**Subject: Maxwell Underground Coal Mine – Approval of Extraction Plan for Whynot Seams Panels 2 to 5**

I refer to the Maxwell Underground Coal Mine Extraction Plan for the Whynot Seam Panels 2 to 5 (Document Reference Number MXC\_MP\_EC\_20, dated November 2024), which has been prepared in accordance with condition C8 of Schedule 2 of SSD 9526.

### Department's Consideration of the Whynot Seam Panels 2 to 5 Extraction Plan

Figure 1 | Bord and pillar Panels 2 to 5 Extraction Plan Area

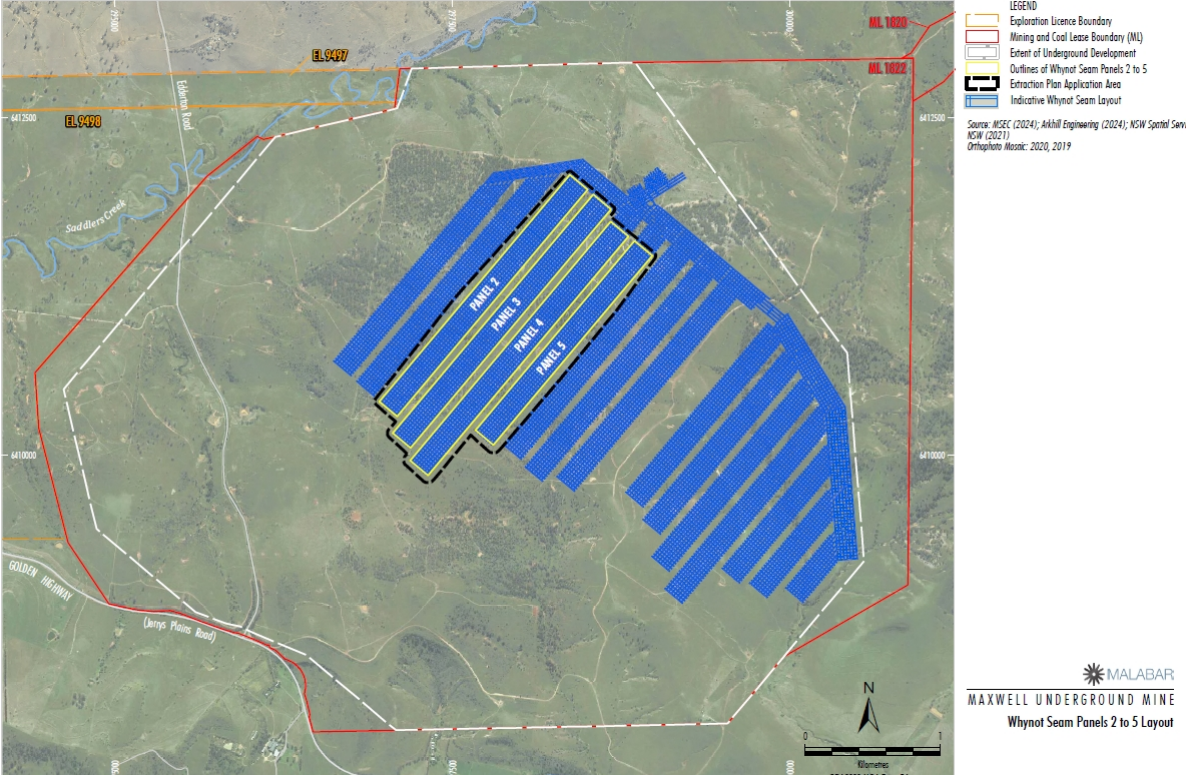
Since MOD 2 was approved in October 2022, mine planning investigations have further refined the layout of the Whynot Seam Panels 2 to 5. The overall panel widths have reduced from 185 m in MOD 2 to 172 m for the Extraction Plan. The overall panel lengths are less than the MOD 2 layout, except for Panel 2 which is 229 m longer. The barrier pillar widths remain the same at 55m.

The extents of Panels 2 to 5 in the Extraction Plan are typically within the extents of the EIS panel layout. The north-eastern end of Panel 2 extends further than the EIS layout, however it is still located within the mining area extent adopted in the EIS.

The subsidence assessment titled '*Maxwell Underground Mine Project: Extraction Plan Application – Subsidence Assessment*' prepared by Mine Subsidence Engineering Consultants (Technical Report 1 of the Extraction Plan), incorporates the revised layout and concluded that the maximum predicted subsidence based on the Extraction Plan layout is less than the maximum predicted subsidence in the EIS. The surface area located within the limit of predicted vertical subsidence for Panels 2 to 5 is also less than the surface area approved in the EIS.

Accordingly, the Department is satisfied that the refinements to the layout of Panels 2 to 5 will result in similar or reduced subsidence related impacts compared to what is currently approved. The Extraction Plan layout for Panels 2 to 5 is considered to be generally in accordance with the development consent SSD 9526 (as modified).
